**ASSESSMENT OF MECHANISMS FOR
EARLY WASTE PACKAGE FAILURES**

**U.S. Nuclear Regulatory Commission
Contract NRC-02-02-012**

**Vijay Jain
Darius Daruwalla
Center for Nuclear Waste Regulatory Analyses**

**Center for Nuclear Waste Regulatory Analyses
San Antonio, Texas**

Figure 4-5. Size Distribution for Indicated Frequency of Occurrence for Outer Surface Breaking Flaws in Waste Package Alloy 22 Lid Weld (CRWMS M&O, 2000a).

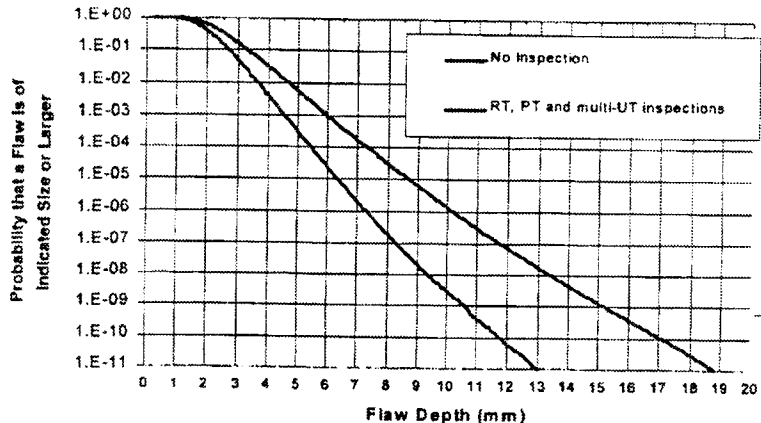
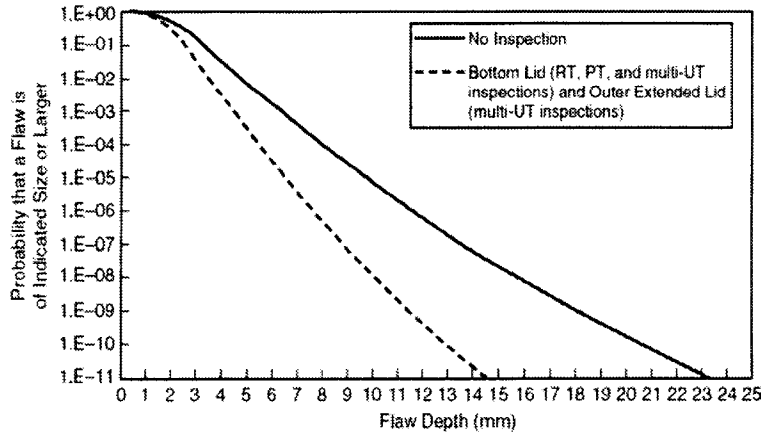
- Published stainless steel data using the RR-PRODIGAL code are bounding for predicting features of flaws in the welds for Alloy 22. DOE assumed the simulation results obtained by Khaleel, et al. (1999) are bounding and the results provided by the RR-PRODIGAL code are conservative by a factor as large as 10 (Simonen and Chapman, 1999). Simonen and Chapman (1999) based their analysis on the measurement of weld flaws greater than 4 mm [0.16 in] depth in pipes and vessels installed in U.S. nuclear power plants and showed that the RR-PRODIGAL code simulations are conservative compared with observed weld flaw frequencies in reactor pressure vessels. However, they completely ignored observed small flaws as reported by Chapman, et al. (1996), Chapman and Simonen (1998), Doctor, et al. (1999), and Schuster, et al., (2000, 1999, and 1998). Validation data showed that for the simulation to match the experimental data, small cracks less than 3 mm [0.12 in] in size have to be ignored. Therefore, the DOE assumption results in a nonconservative flaw frequency distribution of one to two orders of magnitude. The DOE use of simulation results with no verification is inappropriate for estimating the flaw size distribution in Alloy 22.
